August 10, 2017
BOARD OF COUNTY COMMISSIONERS
ORANGE COUNTY, FLORIDA
ADDENDUM NO. 1 / IFB Y17-781 IFB

**PUMP STATIONS 3116 MARTIN CO, 3117 MILLAY DRIVE AND 3216 PADGET
CIRCLE IMPROVEMENTS PACKAGE**

PUMP STATION R/R PACKAGE 10 IMPROVEMENTS
PS 3116 MARTIN Co
EXISTING SITE AND
DEMOLITION PLAN

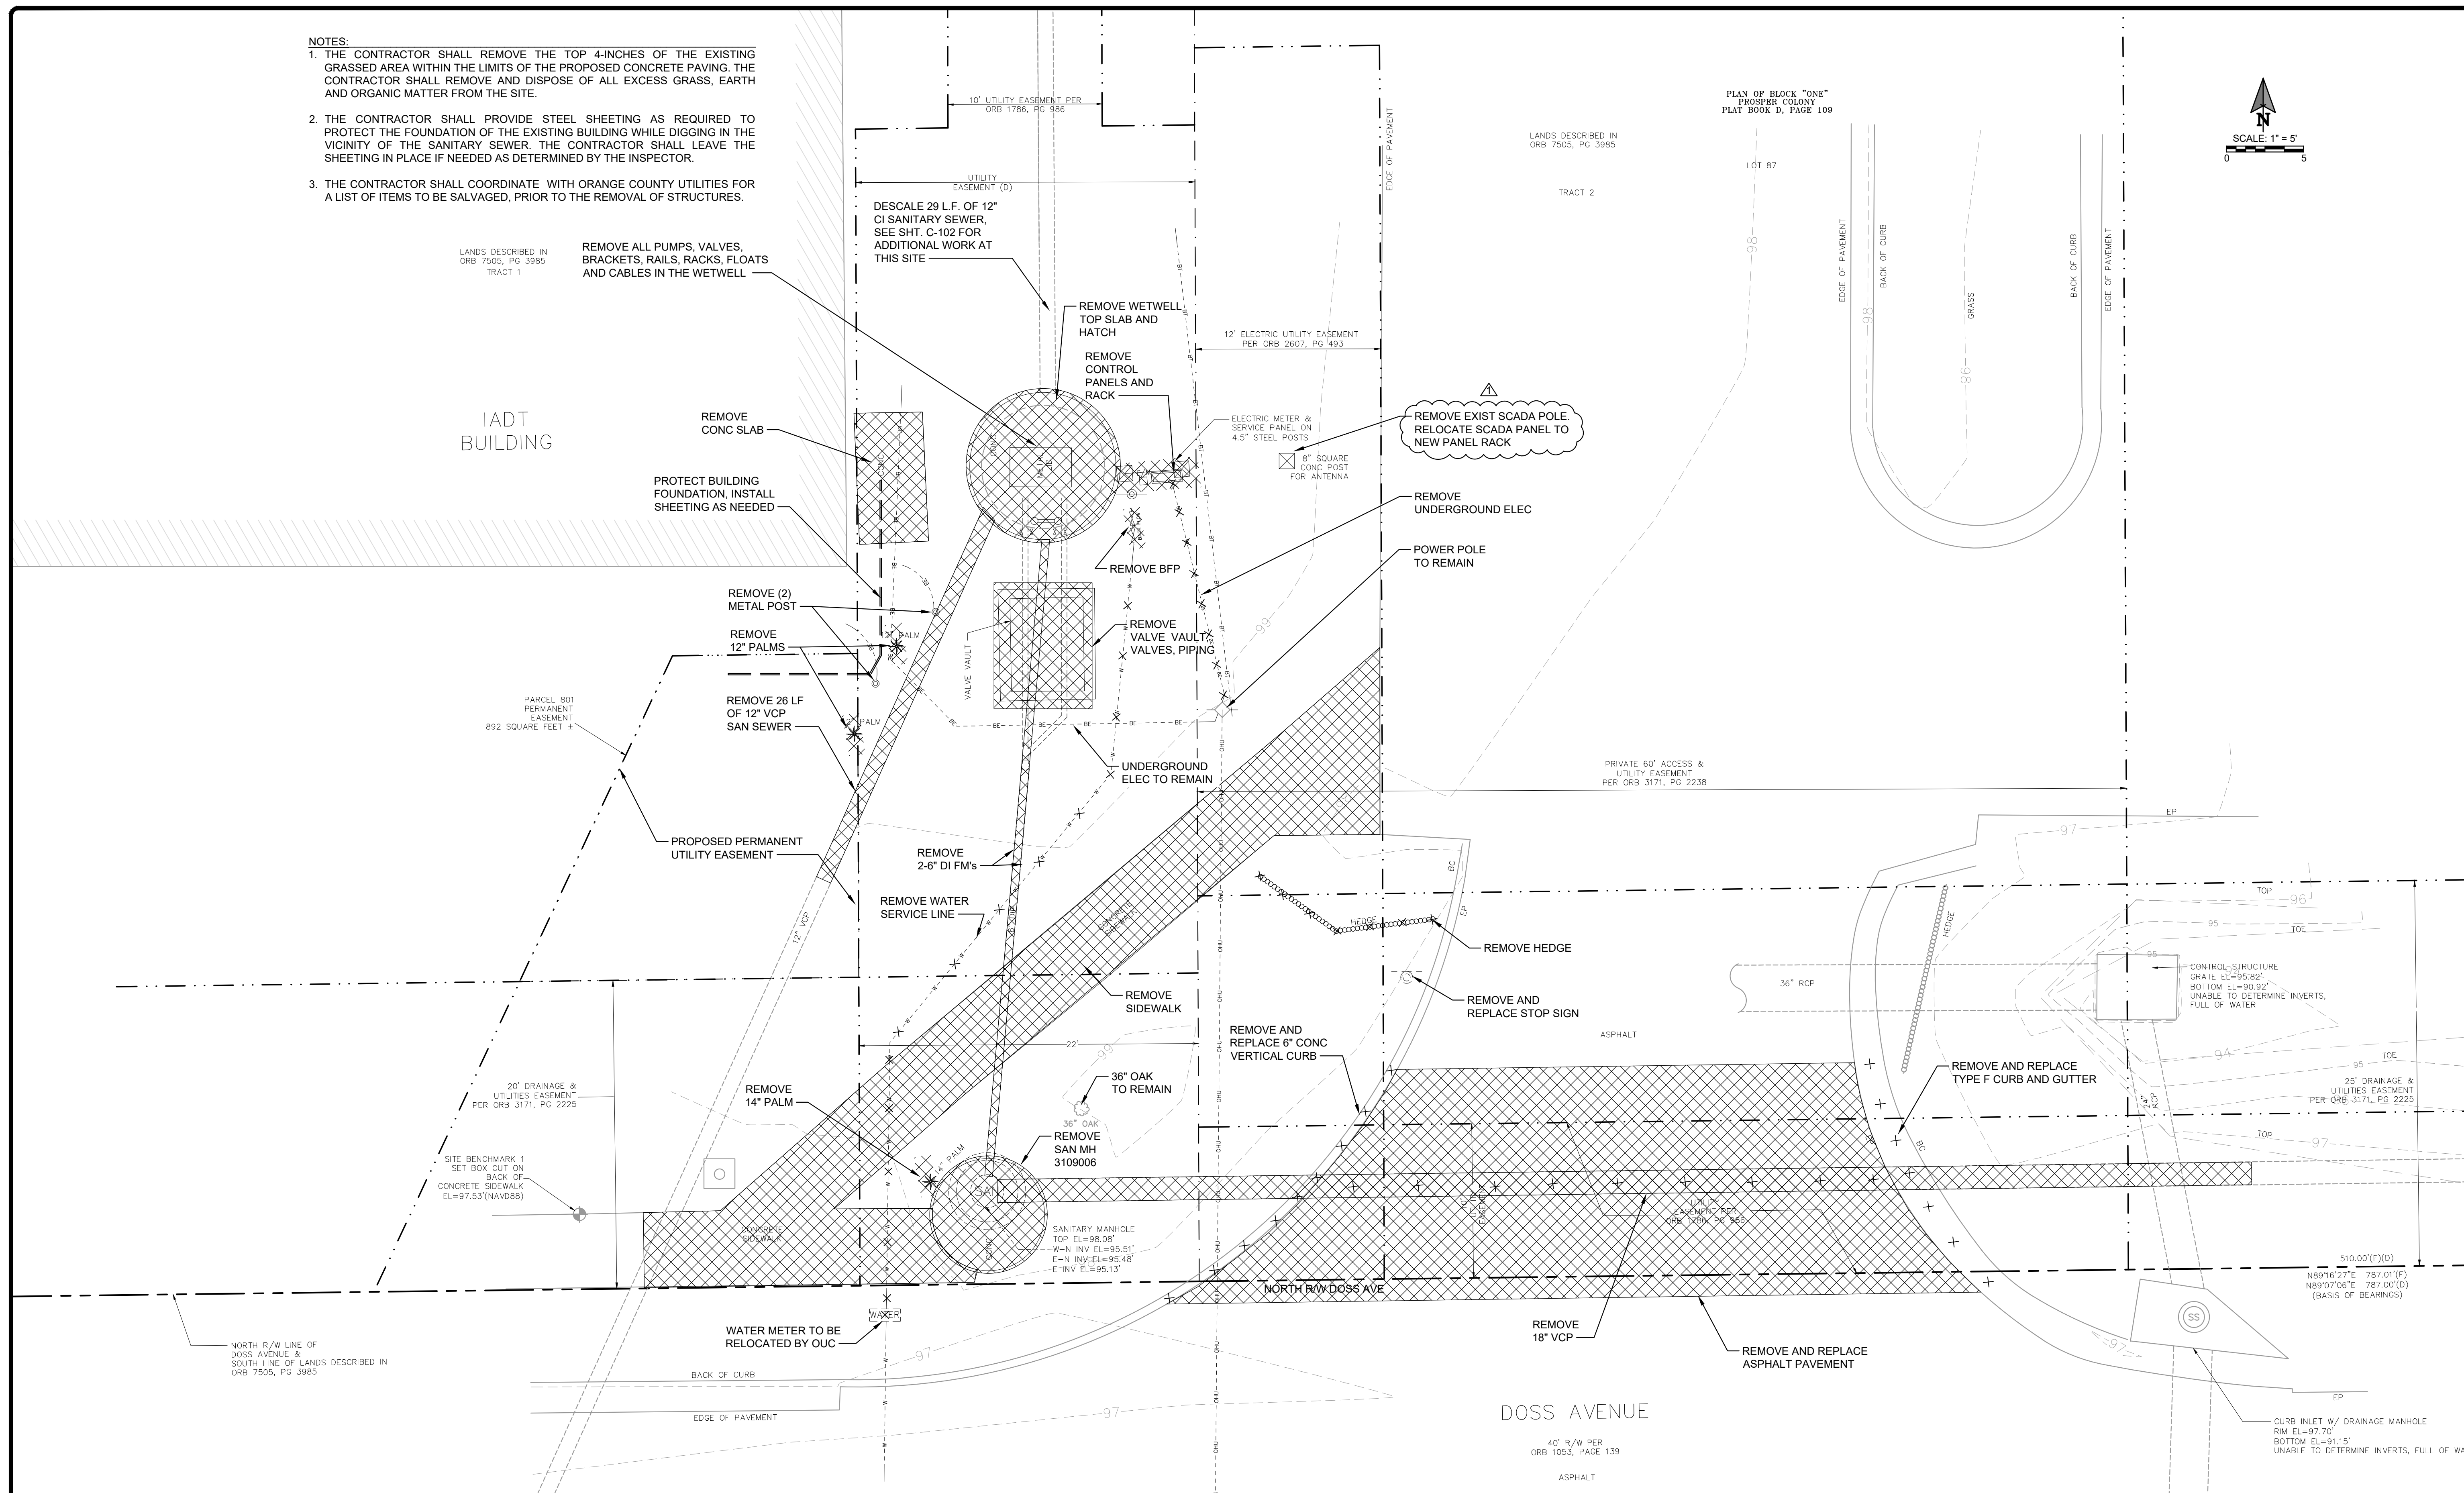
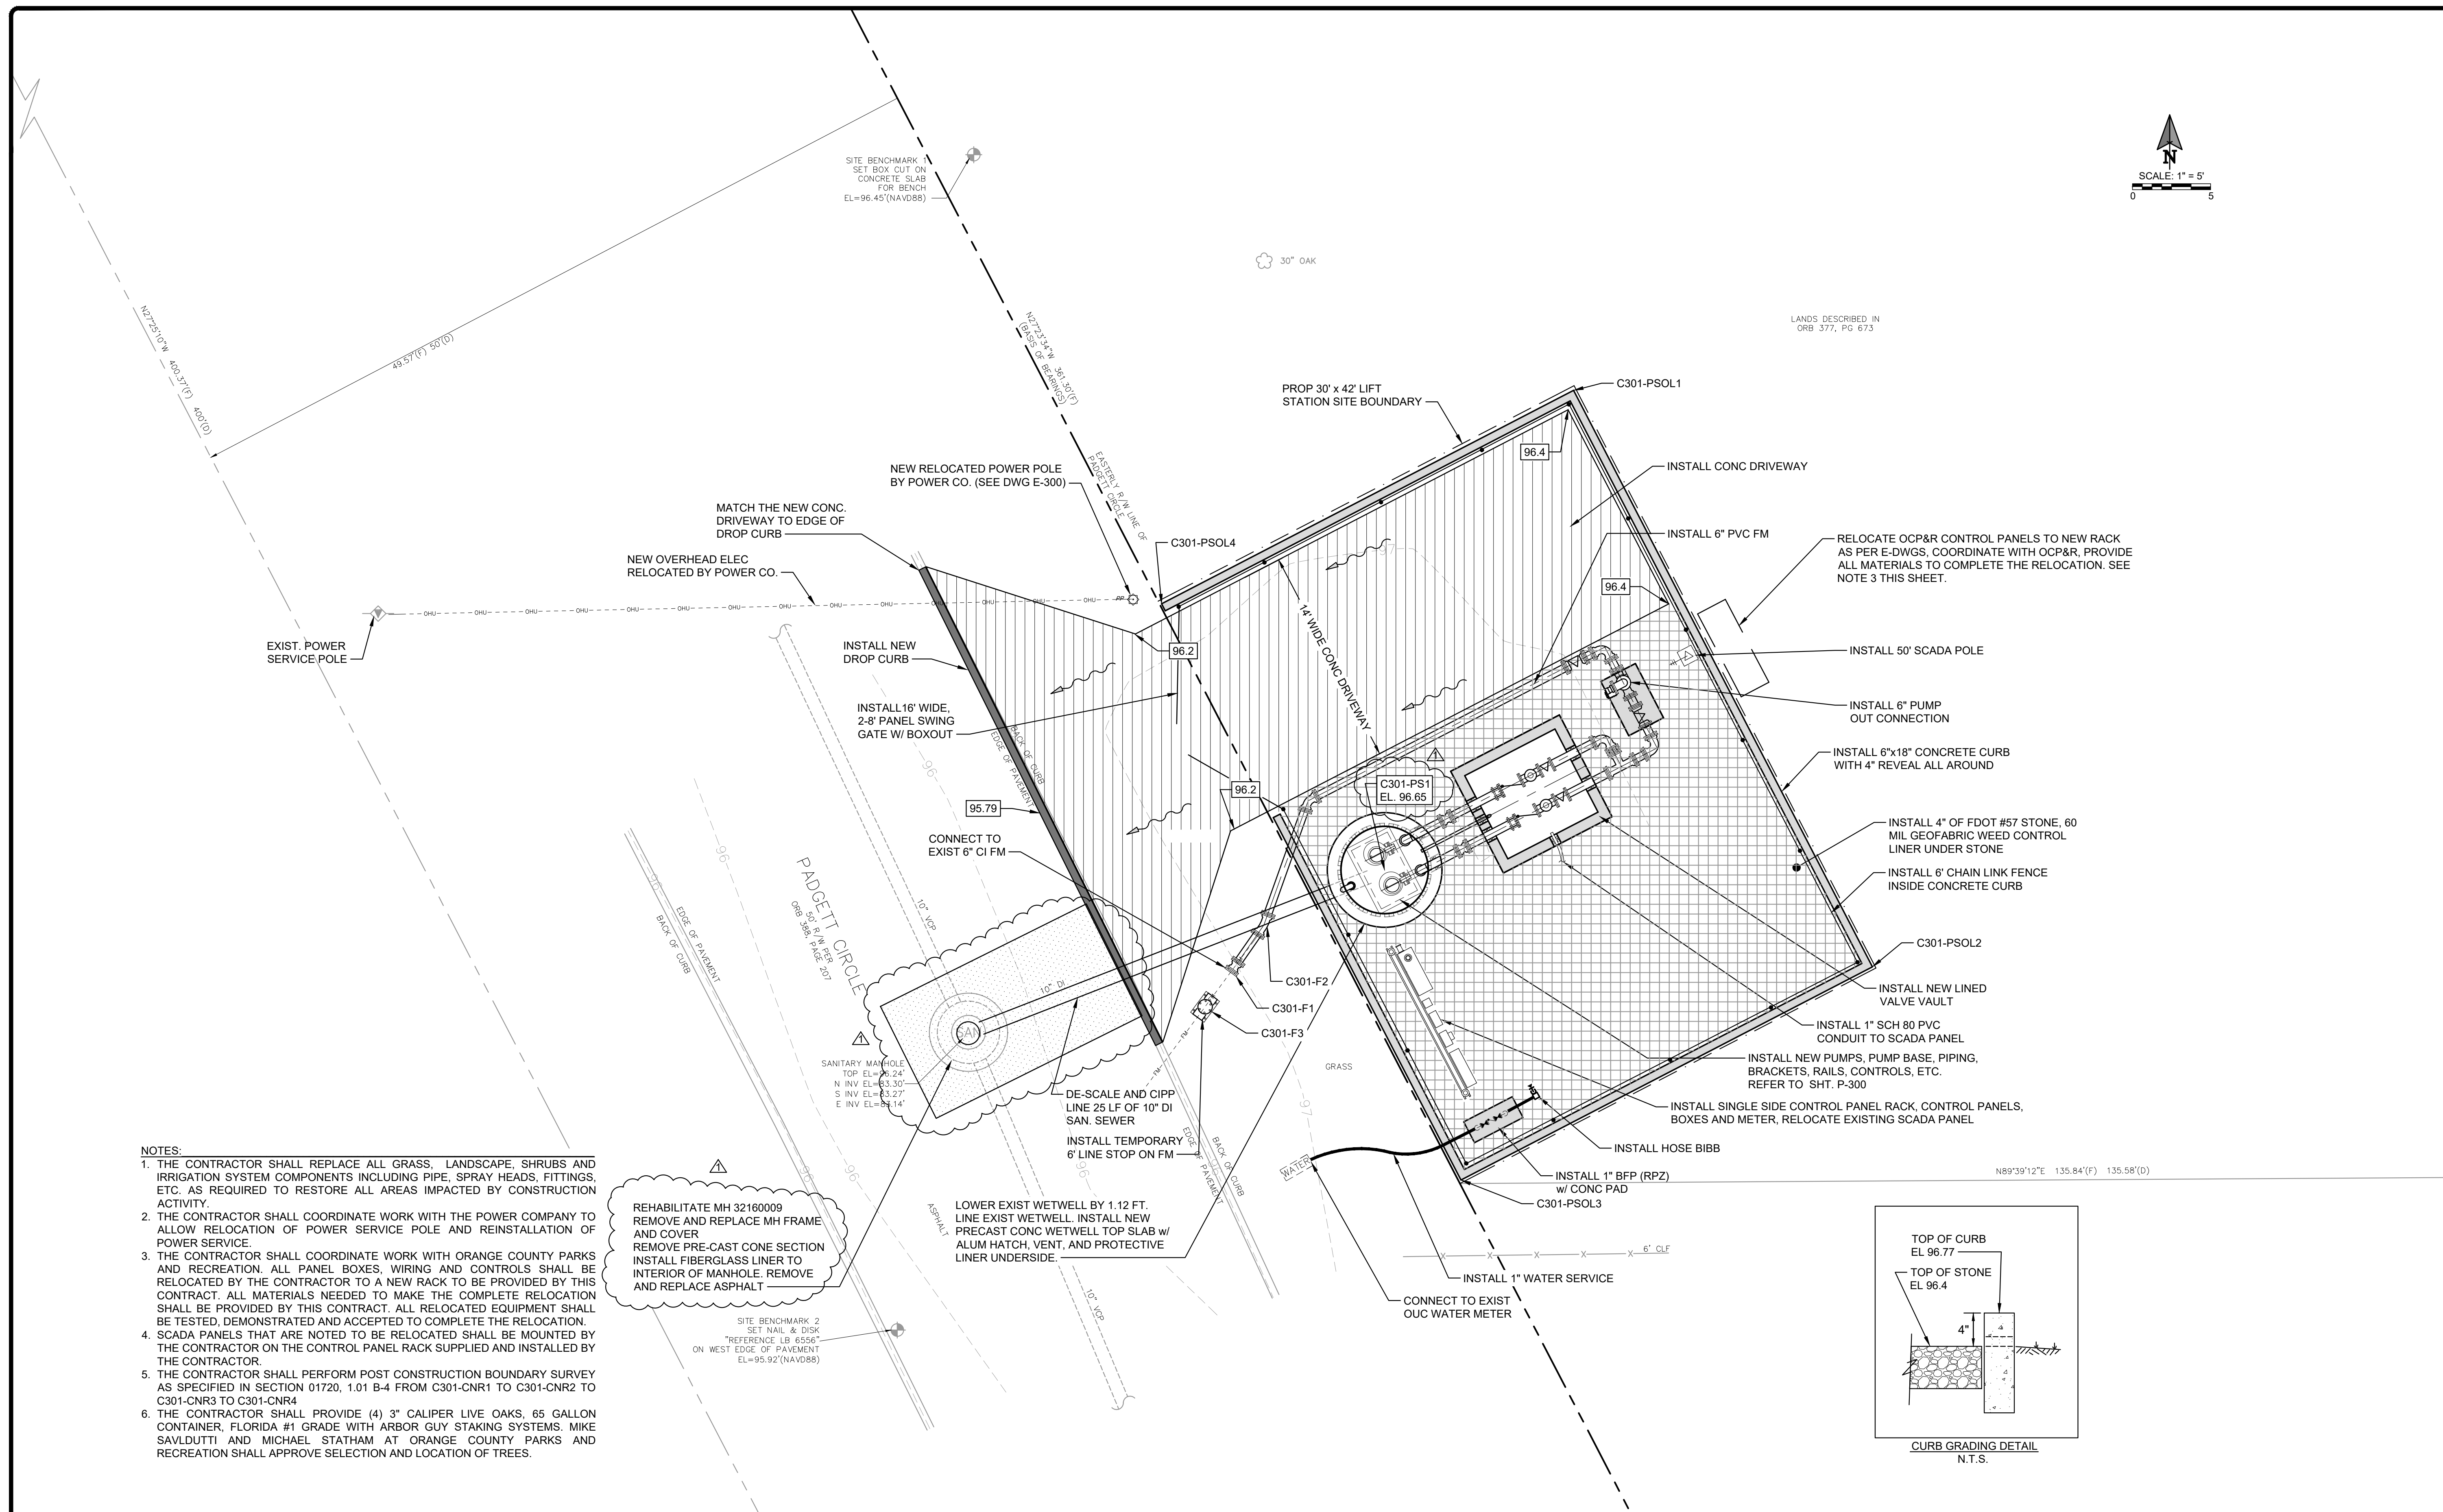
2. Q: Please confirm that existing SCADA panels are to be reused/relocated by the Contractor at all three (3) pump stations. There are conflicting notes in various places of the documents as to if these panels are to be relocated or replaced.

A: Yes, the existing SCADA panels at all three (3) pump stations are to be reused/ relocated by the Contractor. The conflicting call outs have been corrected. Please refer to re-issued Drawing Sheets C-100 and C-101 attached to this Addendum.

PS 3216 PADGETT CIR PUMP STATION IMPROVEMENTS PLAN

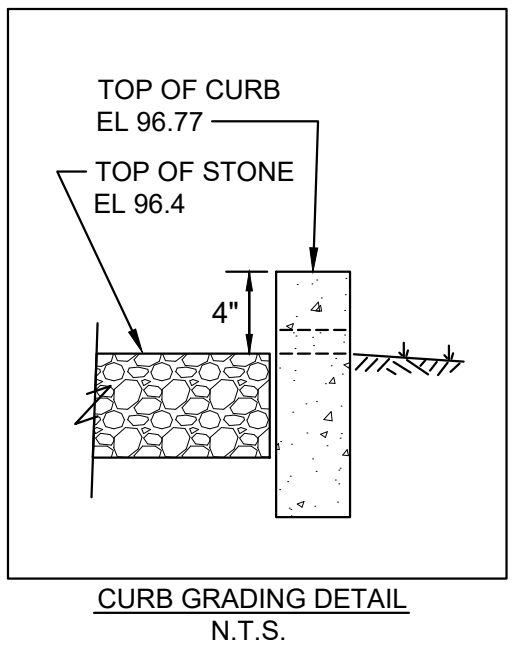
1. Q: Please confirm that an asphalt patch will be accepted by the Owner at PS 3216. It's likely this patch will need to carry from the manhole over to the curb closest to the pump station for by-pass pumping operation.

3. Q: Please confirm the top slab elevation of PS 3216. Drawing Sheet C-301 indicates an elevation of 99.65 and the design table on Drawing Sheet P-300 indicates something different in one place.

A: It is acceptable to increase the asphalt removal and replacement patch in the street around MH 32160009 to the curb in front of the Pump Station to allow for the by-pass pumping operation. Please refer to the re-issued Drawing Sheet C-301 attached to this Addendum.

A: The constructed top slab elevation of PS 3216 should be 96.65. The conflicting call outs have been corrected. Please refer to re-issued Drawing Sheets C-301 and P-300 attached to this Addendum.

REHABILITATE MH 32160009
 REMOVE AND REPLACE MH FRAME AND COVER
 REMOVE PRE-CAST CONE SECTION
 INSTALL FIBERGLASS LINER TO INTERIOR OF MANHOLE. REMOVE AND REPLACE ASPHALT
